## SERVICE LETTER 19-04-30

<b>Date Released:</b>	June 20, 2019
<b>Date Effective:</b>	June 20, 2019
<b>Subject:</b>	Elastomer nose gear leg and engine mount retrofit
<b>Affected Models:</b>	Tricycle gear RV-7A/9A
<b>Required Action:</b>	None – Optional change
<b>Time of Compliance:</b>	N/A
<b>Supersedes Notice:</b>	NONE

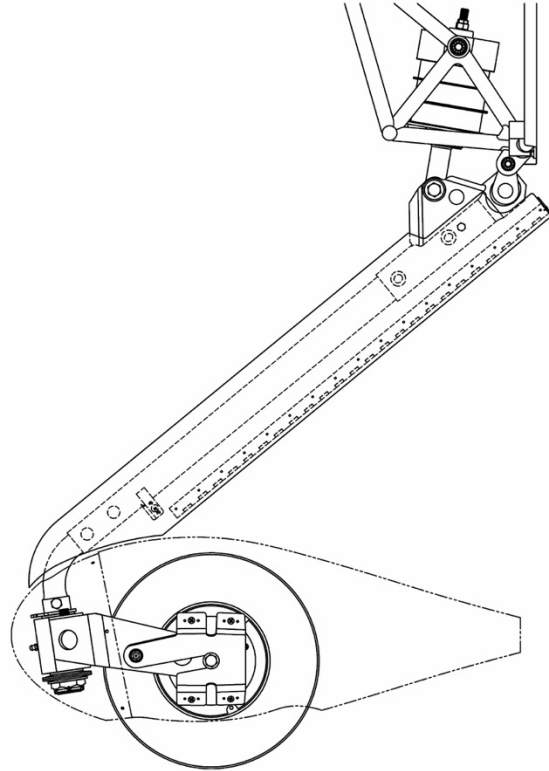
By way of illustration, during installation of the new mount and gear system on the Van's Aircraft RV-9A factory demonstrator aircraft, the following changes were measured before and after the modifications described in this service letter had been completed.

- **Empty weight:** Increased from 1088 lbs to 1093 lbs (+5 lbs)
- **Nose wheel arm:** Moved forward 1.18 inches
- **CG in specific typical max-gross-weight loading scenario:** Moved forward from 81.447 inches (21.60%) to 81.174 inches (21.08%)
- **Nose wheel weight measured in specific typical max-gross-weight loading scenario:** Increased from 318.0 lbs to 333.3 lbs (+15.3 lbs)
- **Cooling changes:** Due to the changes to the engine mount and gear structure near the exit area of the cowl, exit airflow was reduced. Louvers were added to increase exit airflow and properly cool the engine. Net result on the demonstrator aircraft after all modifications including louvers was slightly lower operating engine temperatures than before the changes, with improvement especially noted during climbs. Airspeed was unaffected.

**FIGURE 1:** DRILL OUT FIREWALL RIVETS

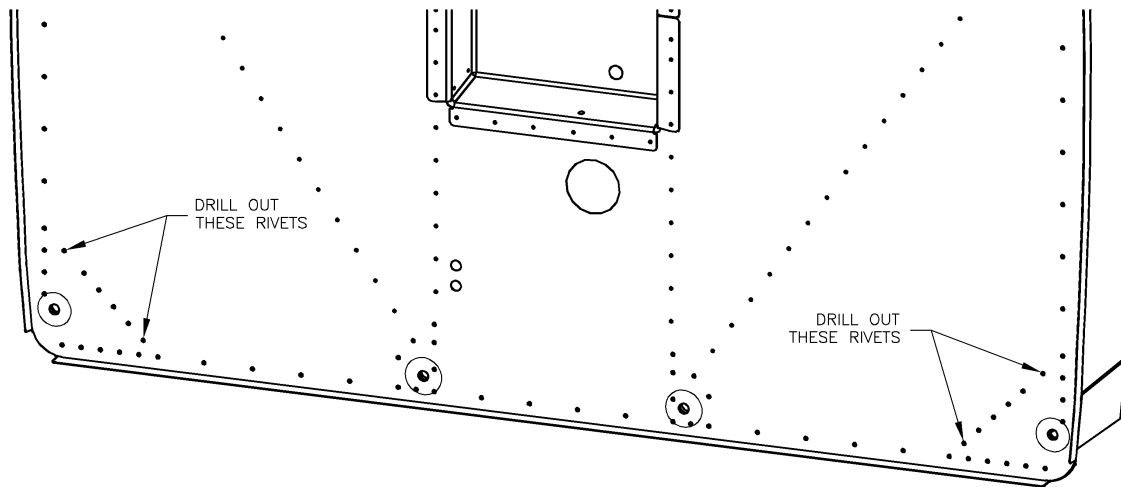
**Step 7:** Drill out the two indicated firewall rivets next to both lower, outboard engine mount attachment points. See Figure 1.

**FIGURE 2: VA-270 SUPPORT PLATES**

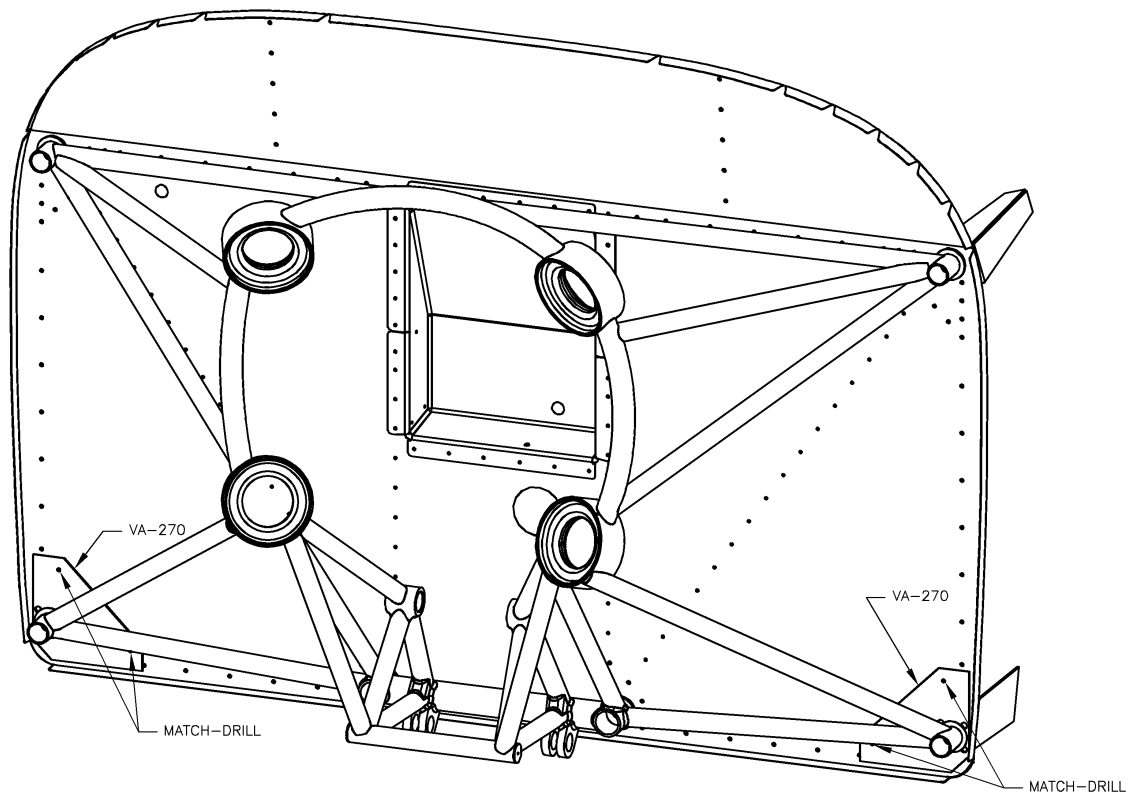
**Step 9:** Slip the VA-270 Support Plates between the firewall and engine mount with the circular cut-out in the plates capturing the outboard engine mount bushings as shown in Figure 2.
